DESIGN MEMORANDUM NO. 02-25; CONSTRUCTION MEMORANDUM CM 25-04

SUBJECT: Implementation of Guardrail End Treatment Type 2M

RBR-025 GUARDRAIL END TREATMENT TYPE 2M (TRAILING END TERMINAL)

SHEET 001: GUARDRAIL END TREATMENT TYPE 2M
(TRAILING END TERMINAL)

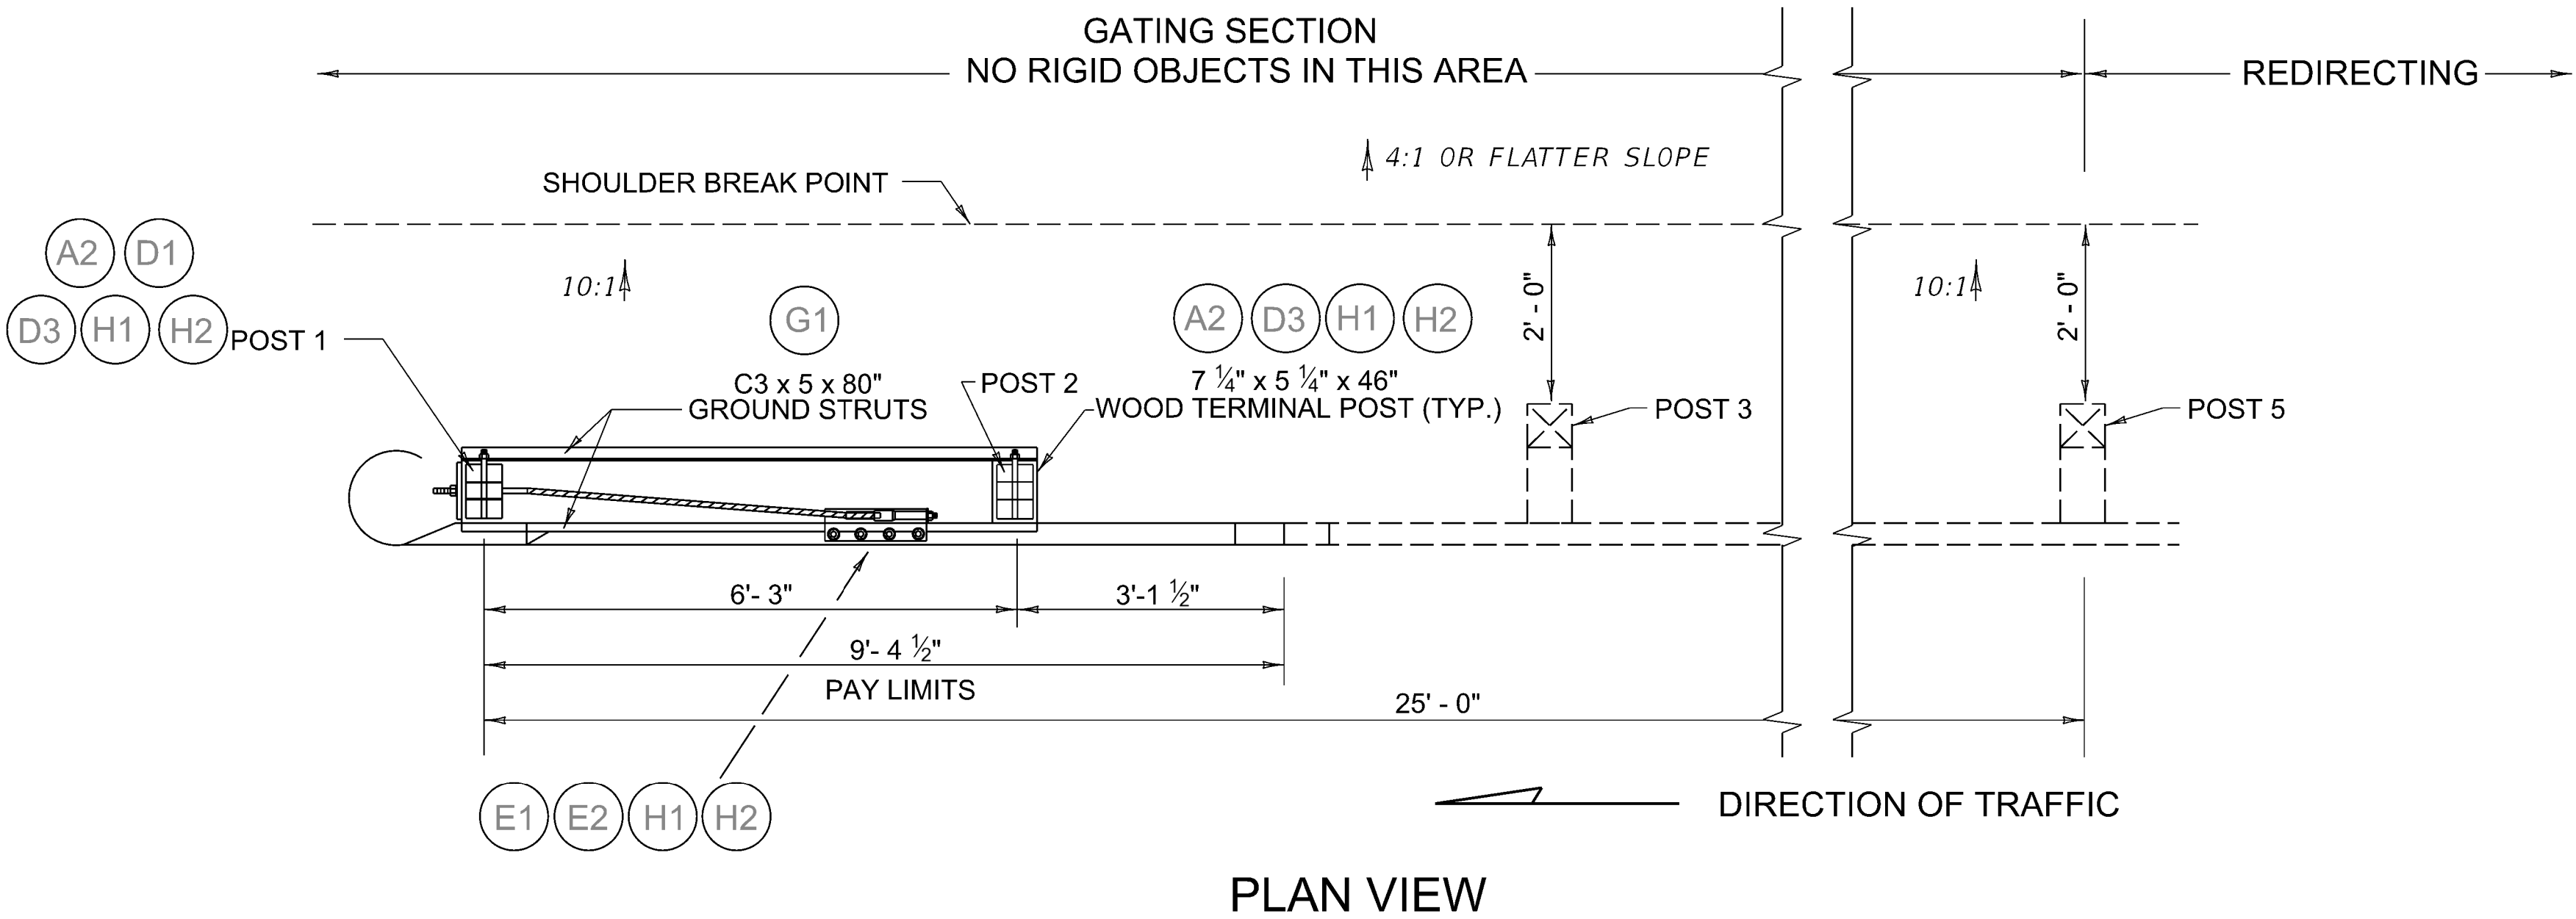
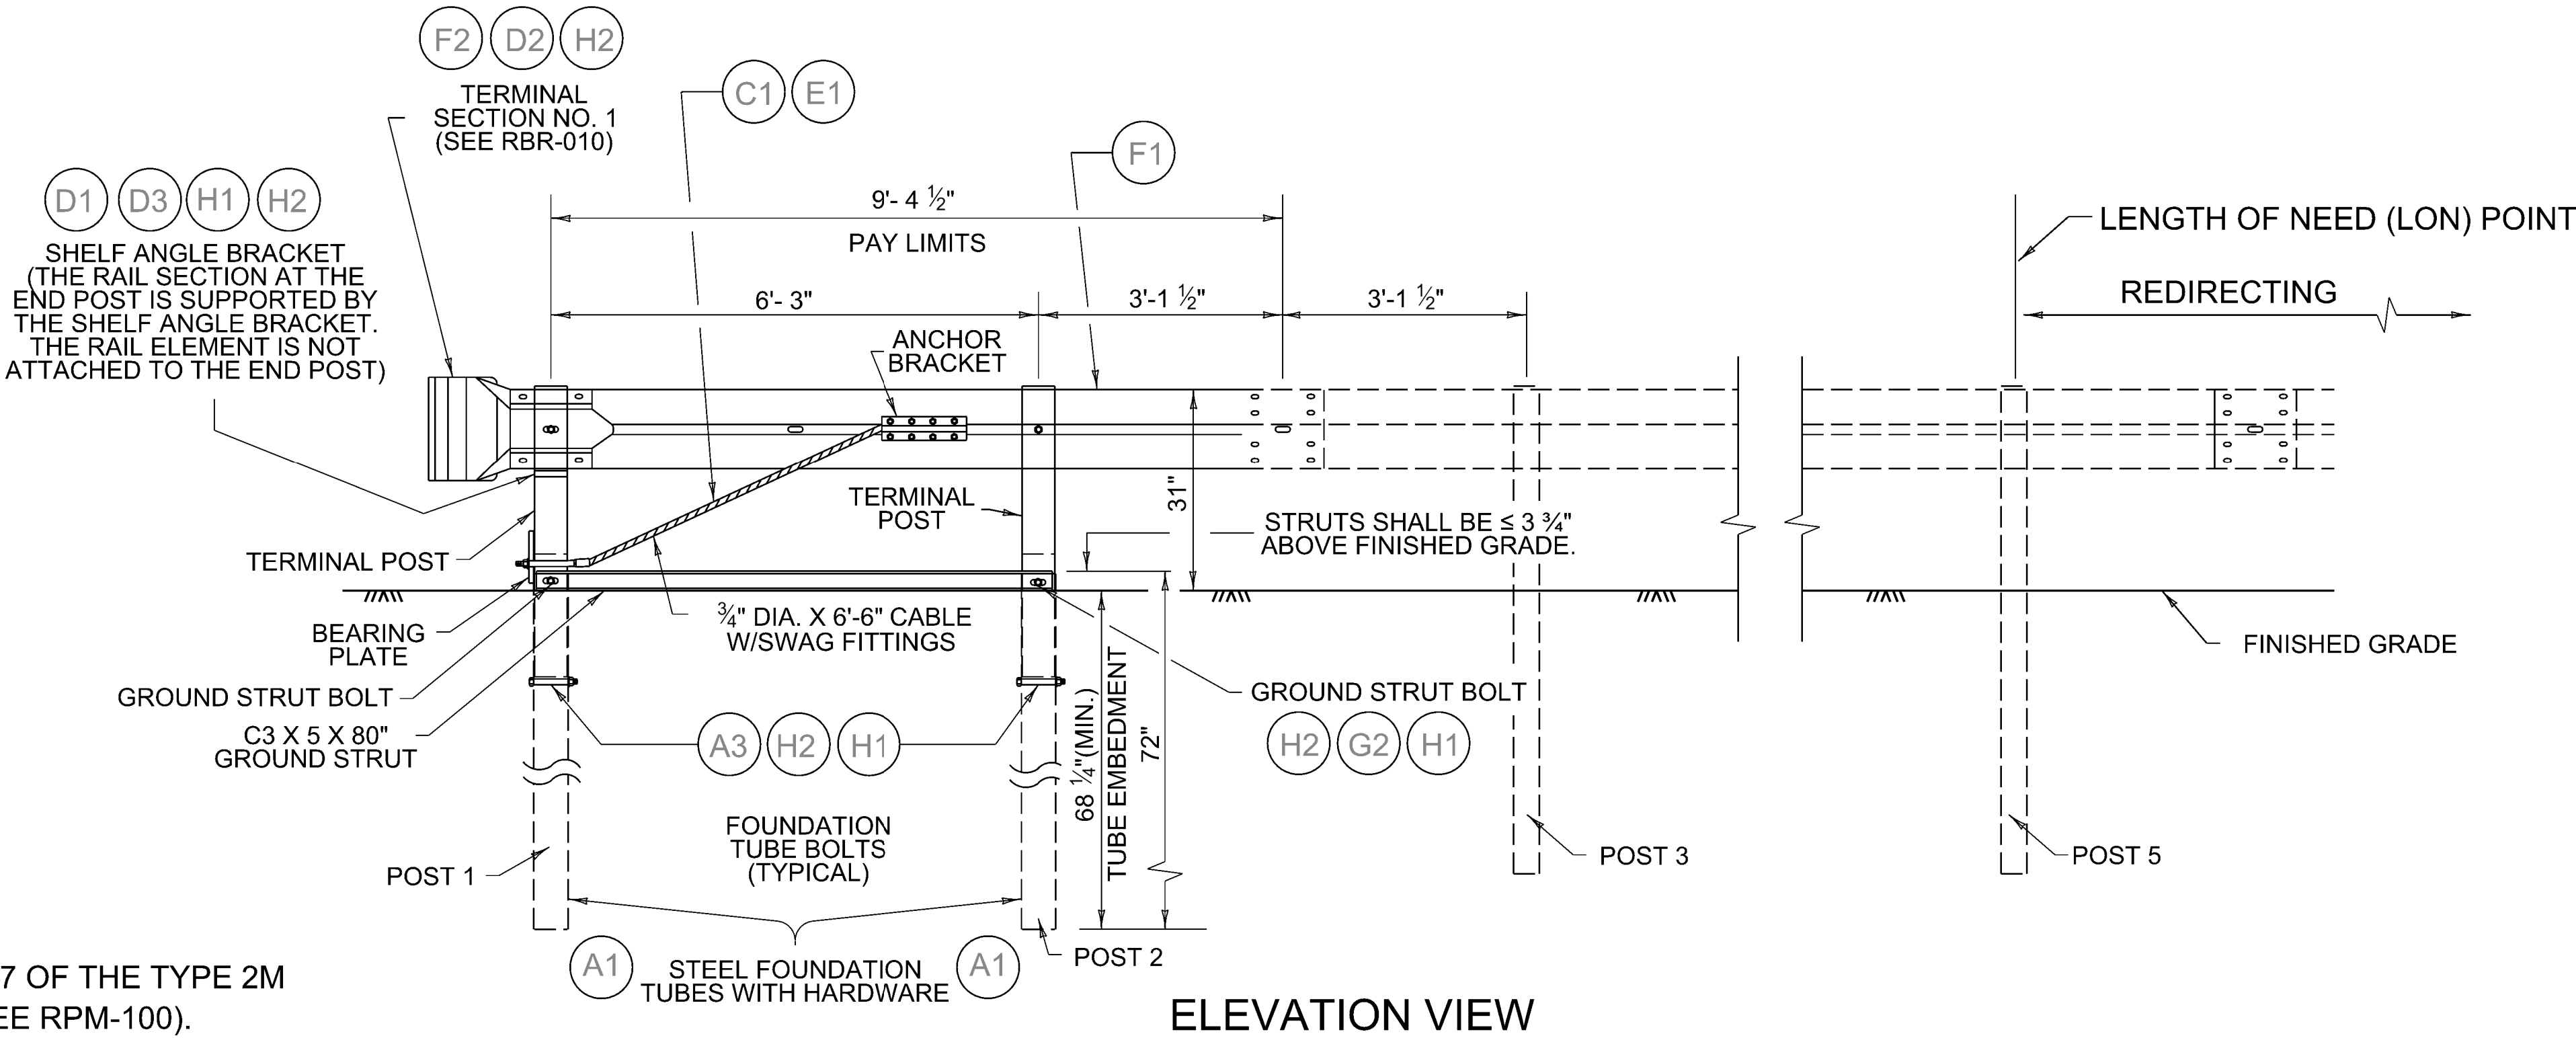
The Division of Highway Design is publishing a revised **Standard Drawing RBR-025, Guardrail End Treatment Type 2M**. This updated drawing introduces a MASH-compliant, non-proprietary trailing-end terminal and anchor designed for use with the 31-inch Midwest Guardrail System (MGS) W-beam, Kentucky's standard guardrail system.

This drawing replaces the previous version of RBR-025, which featured the Type 2A terminal — a pre-MASH design that is no longer acceptable for new installations.

Effective immediately, designers shall use the Guardrail End Treatment Type 2M in place of the discontinued Type 2A at all applicable project locations. For projects currently under construction, all proposed Type 2A end treatments shall be revised to a Type 2M end treatment. If a 2A end treatment has already been installed, the project engineers may elect to leave it in place if deemed appropriate for the specific project conditions. In cases where a Type 2A end treatment was previously specified on the leading end of a guardrail run, it must be replaced with a Guardrail End Treatment Type 1 or Type 4A. The guardrail should be extended as needed to satisfy length-of-need requirements.

Revision	Description of Changes
RBR-025-06-S	➤ Renamed Guardrail End Treatment Type 2A to Type 2M (Trailing End Terminal) ➤ Updated the design to a MASH-compliant terminal for use on the downstream trailing end of guardrail systems
DATE: 2025-07-17
